**Study Area Characterization Work Plan Addendum Number 1
Additional Field Investigation Activities**

Site Name and Location:	Study Area, Corning, NY
Order on Consent and Administrative Settlement:	NYSDEC Project ID 851046
Corning Incorporated Project Coordinator:	Mike Ford
NYSDEC Project Coordinator:	Gregory B. MacLean
Date:	October 24, 2014

**RE: Study Area Characterization Work Plan Addendum Number 1 -
Additional Field Investigation Activities; and
Groundwater Wells proposal
Study Area, Project No. 851046
Corning (C), Steuben (Co)**

Figure 1
 Sample Locations
 Corning Christian Academy Property

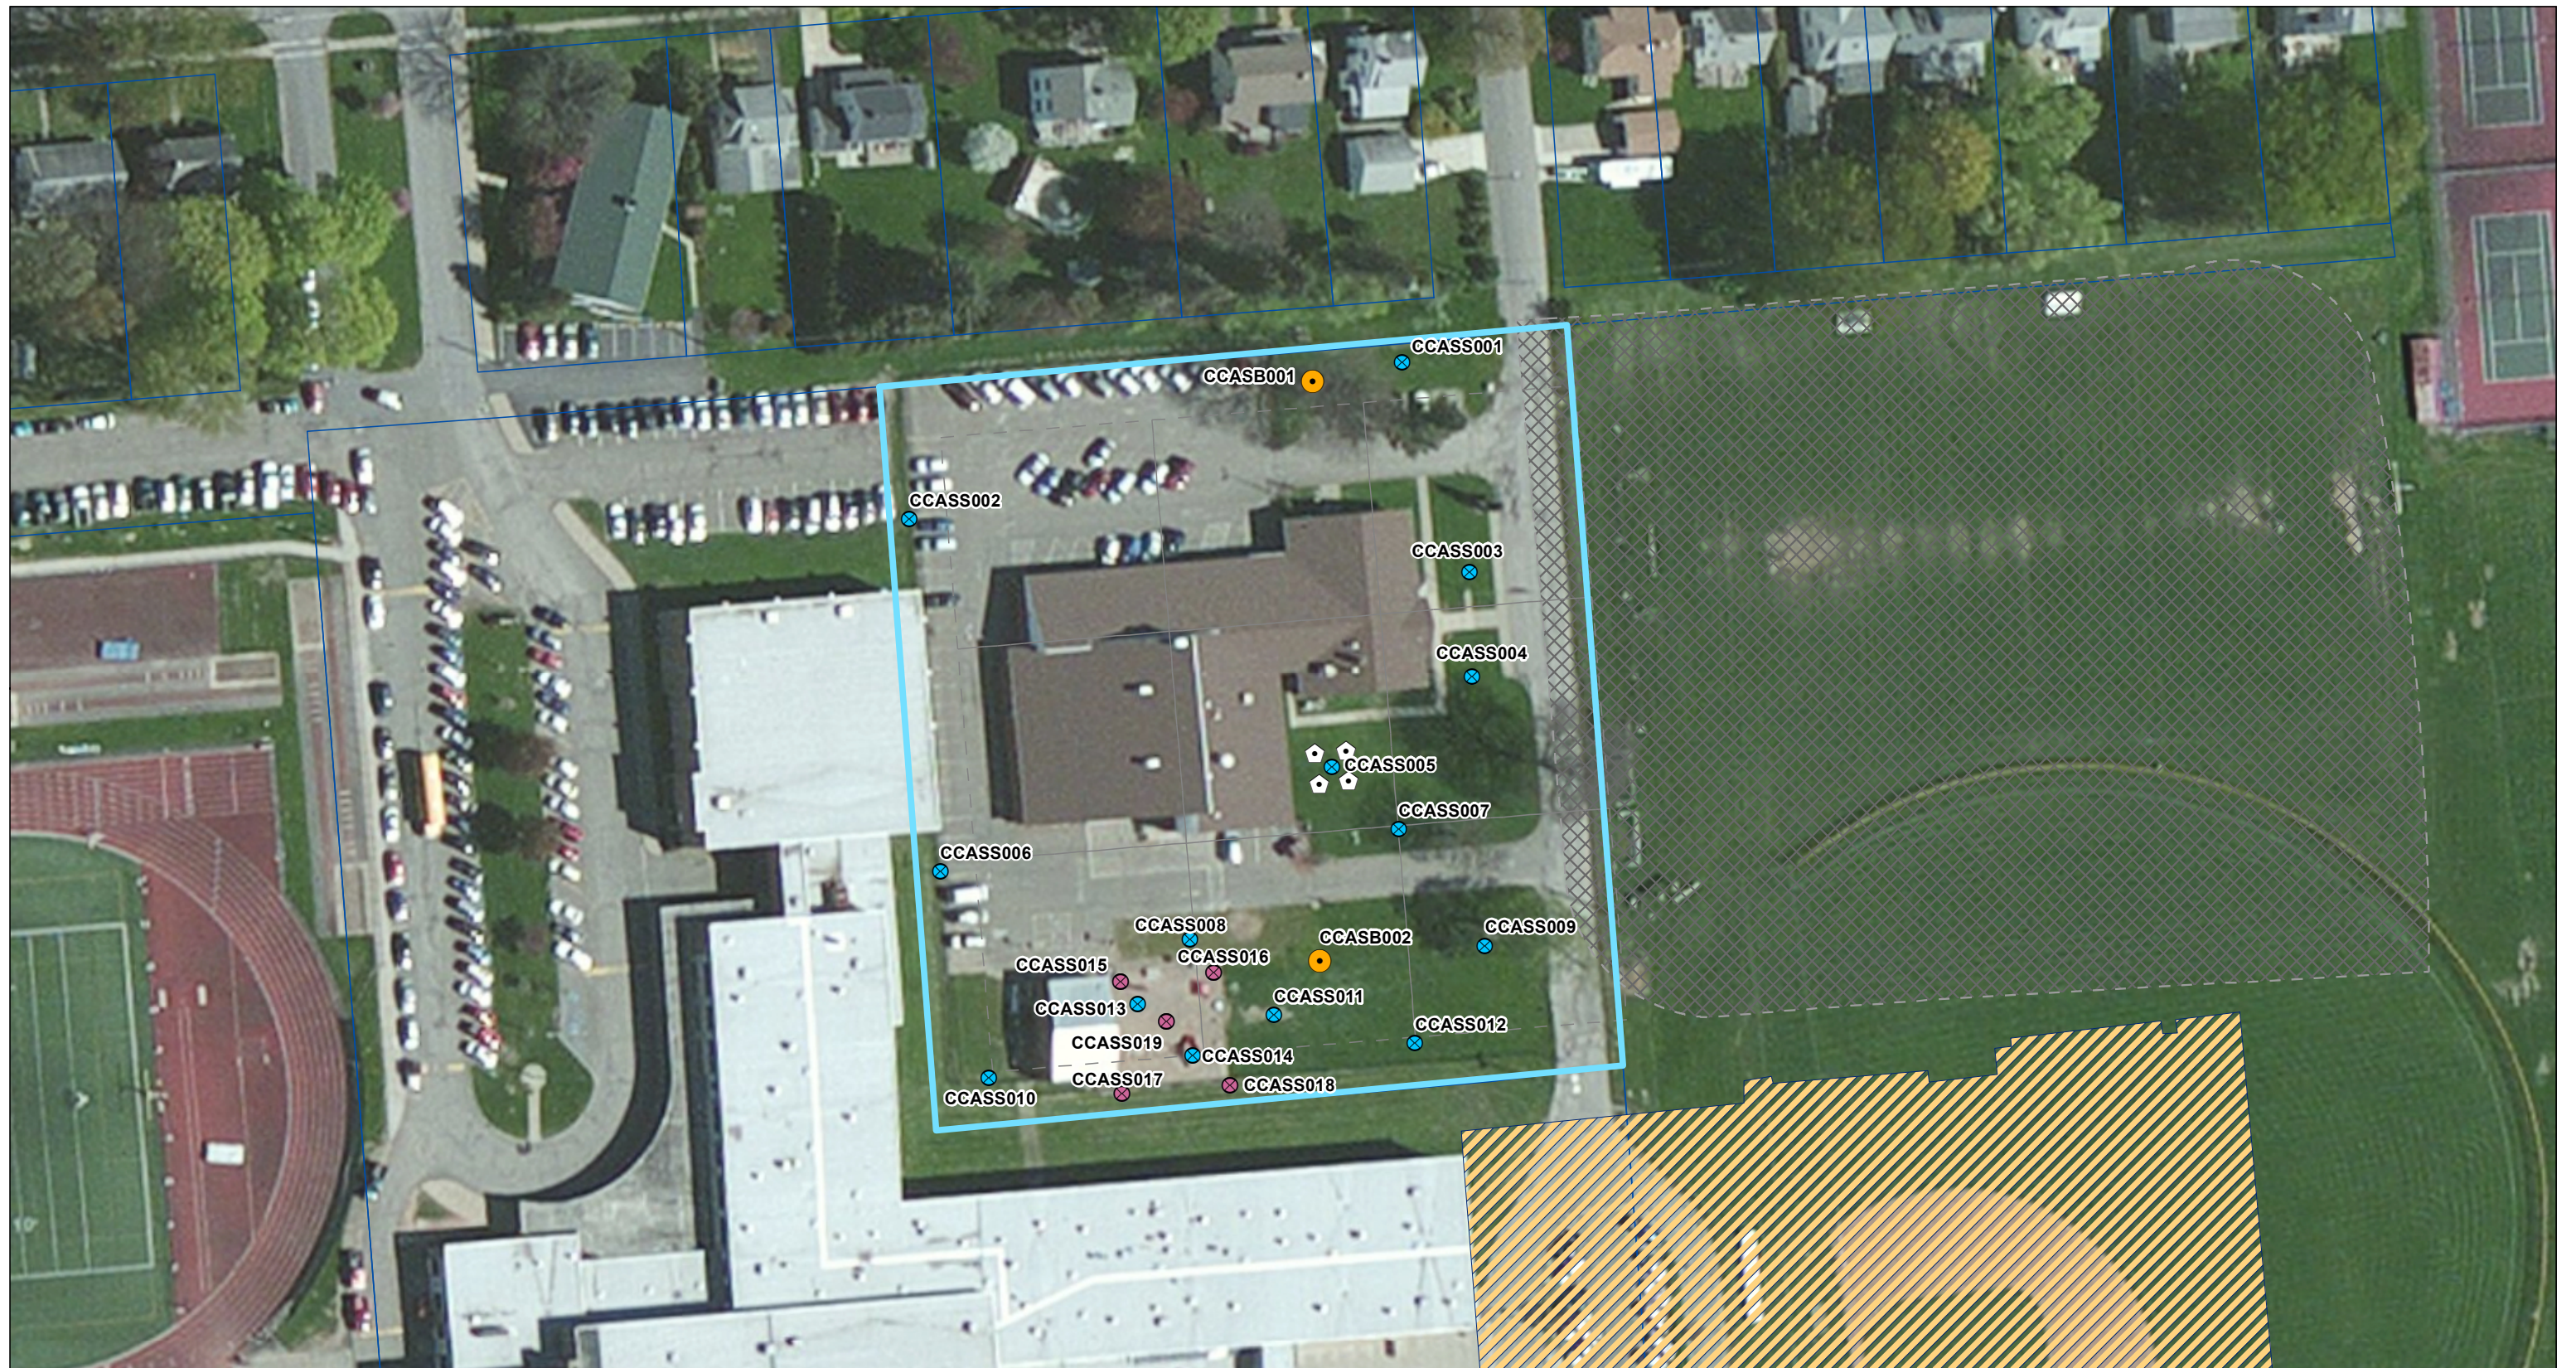
Preliminary, un-validated analytical data indicate an arsenic concentration of 34 milligrams per kilogram (mg/kg) at 2 to 24 inches below ground surface (in bgs) at sample location CCASS005. In order to determine the extent of arsenic in the shallow soils, additional samples will be collected on an approximate 10 foot by 10 foot grid around sample location CCASS005, at the locations shown on Figure 1 attached. The

Figure 2
 Sample Locations
 Residential Area at the
 Eastern End of Coming Boulevard

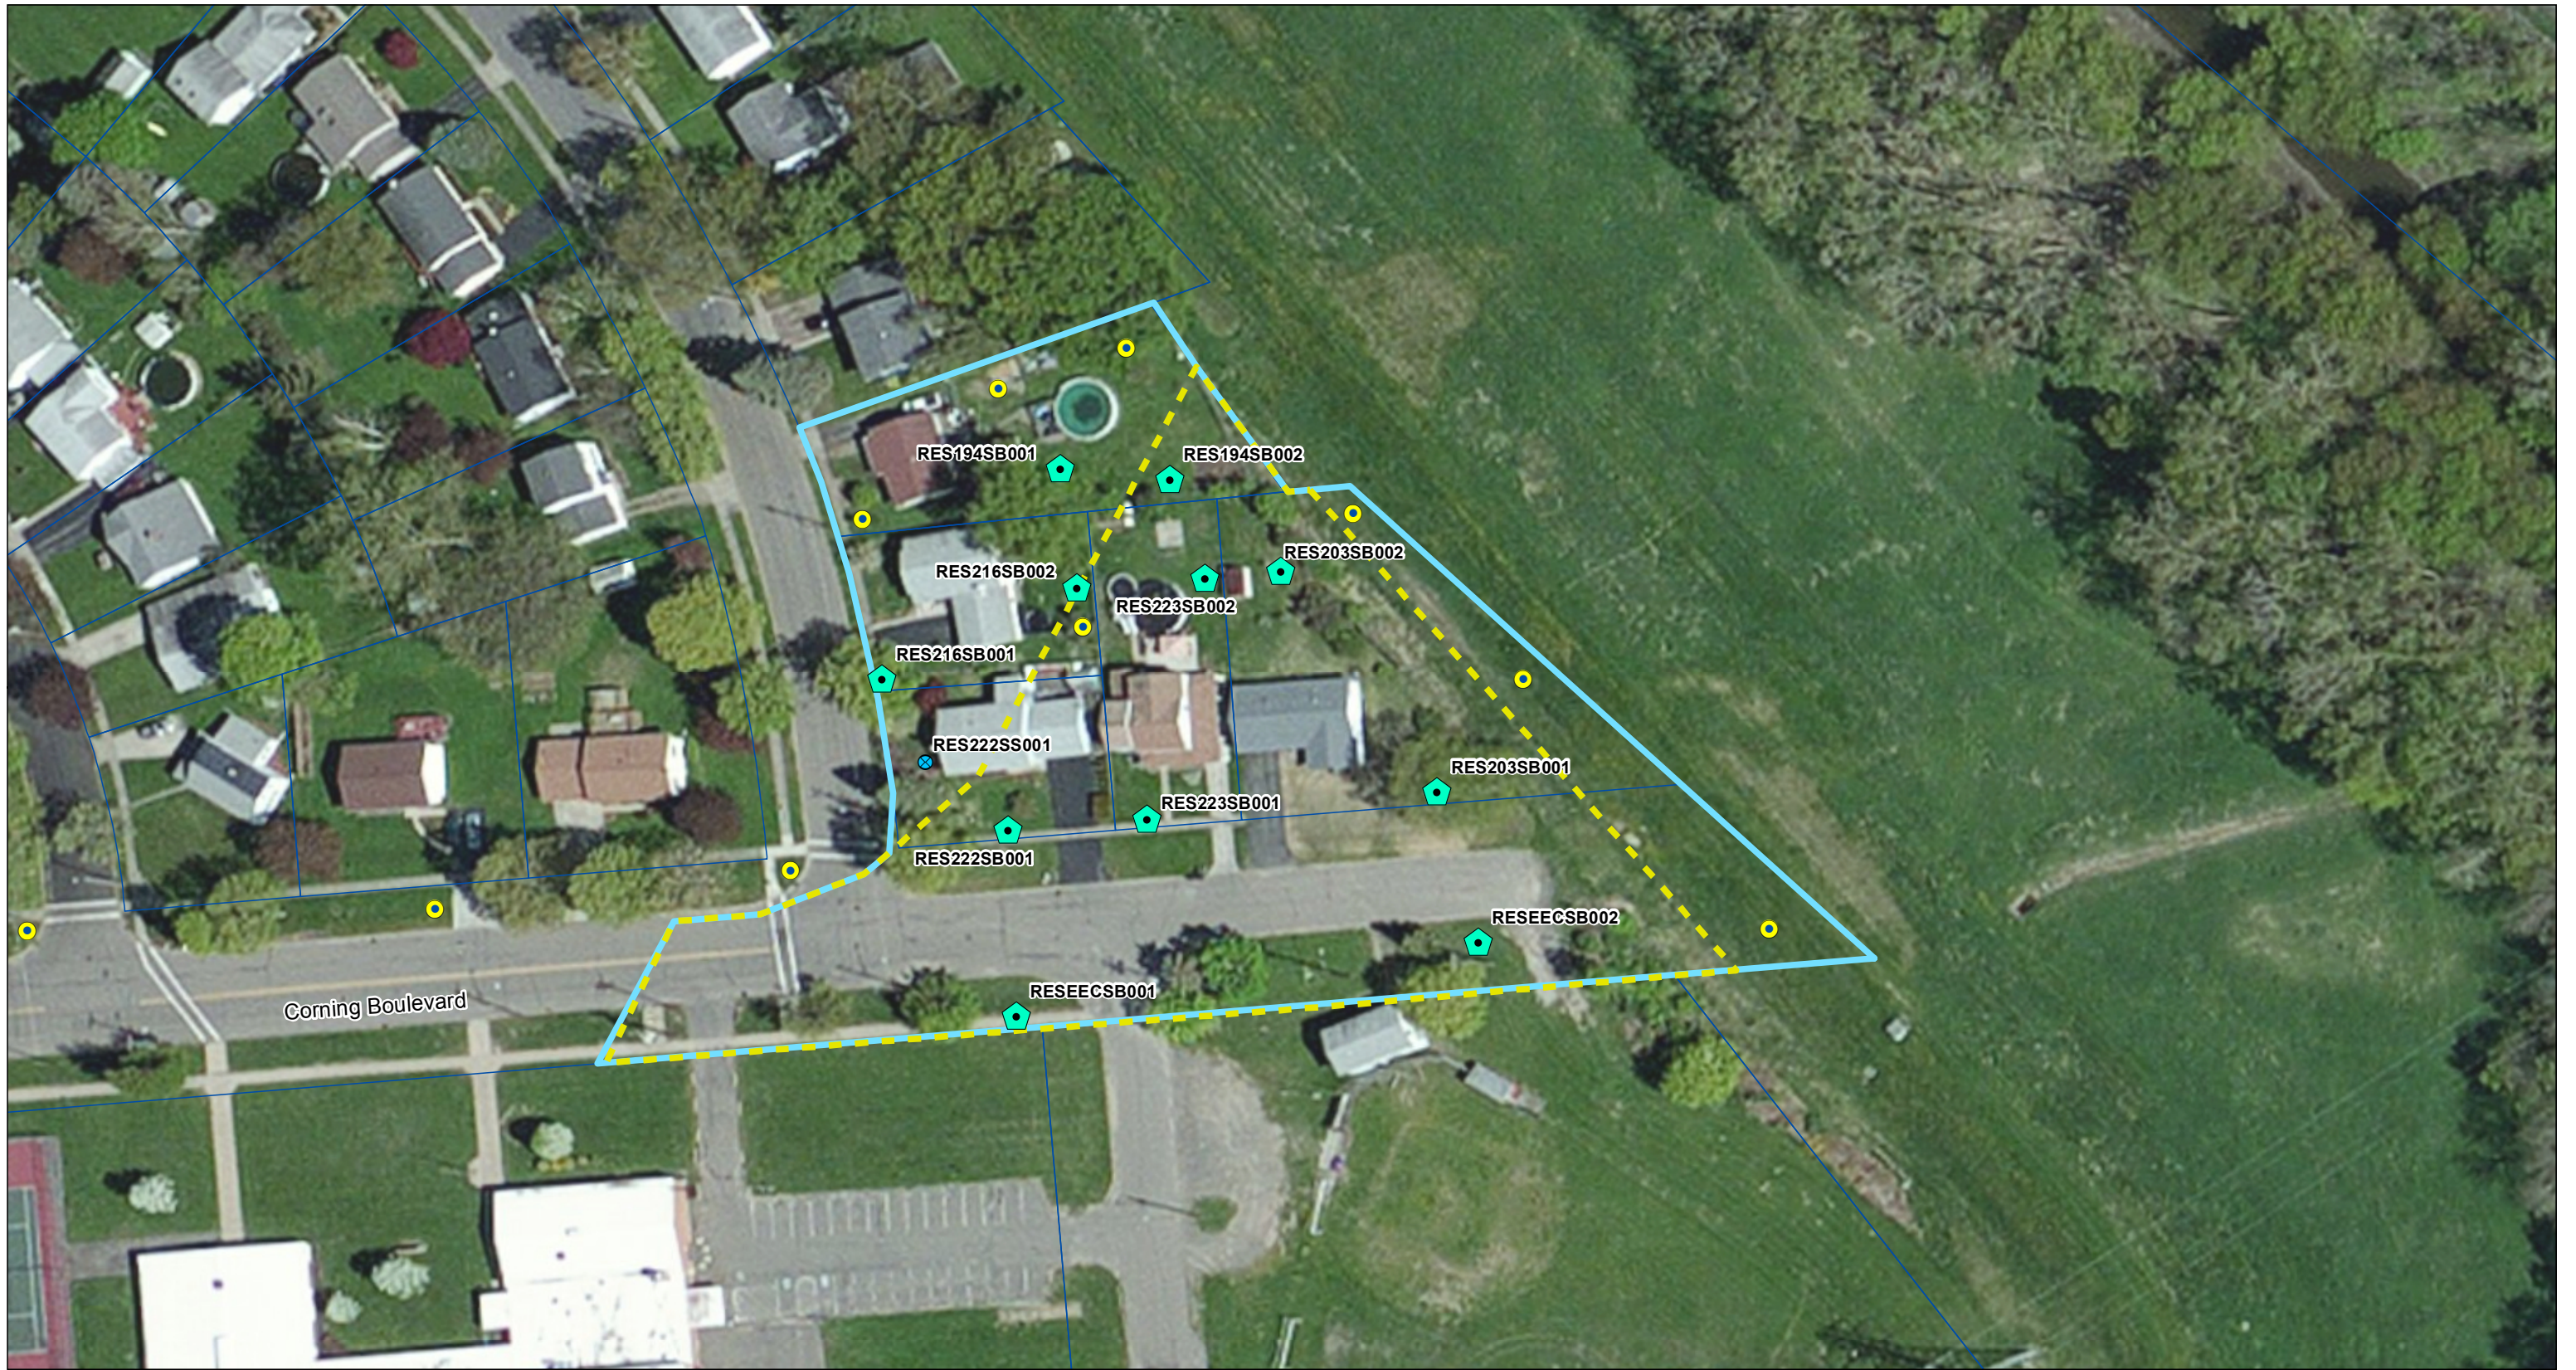
Based on preliminary, un-validated analytical data for soil samples collected in the Residential Area at the Eastern End of Corning Boulevard, ten (10) additional soil borings are proposed to be installed to assess the nature and extent of fill material encountered within this subarea. The locations of the proposed additional soil borings in the Residential Area at the Eastern End of Corning Boulevard are shown on Figure 2 attached and described below.

- Two (2) soil borings will be installed along the northern parcel boundary of residential property RES194 to determine the horizontal extent of fill material to the north.
- One (1) soil boring will be installed along the western parcel boundary of residential property RES194 to determine the horizontal extent of fill material to the west.
- One (1) soil boring will be installed south of soil boring RES216SB002 to further assess the nature of fill material in the vicinity of this soil boring. The nature of the ash layer at 2 to 4 ft bgs in the vicinity of soil boring RES216SB002 will be further assessed and confirmed by collecting an additional sample from the proposed additional soil boring.
- Three (3) soil borings will be installed along the north side of Corning Boulevard within the City of Corning right-of-way to determine the horizontal extent of fill material to the west.

- Two (2) soil borings will be installed along the eastern parcel boundary of residential property RES203 to determine the horizontal extent of fill material to the east.
- One (1) soil boring will be installed east of the eastern end Corning Boulevard within the City of Corning right-of-way to determine the horizontal extent of fill material to the east.
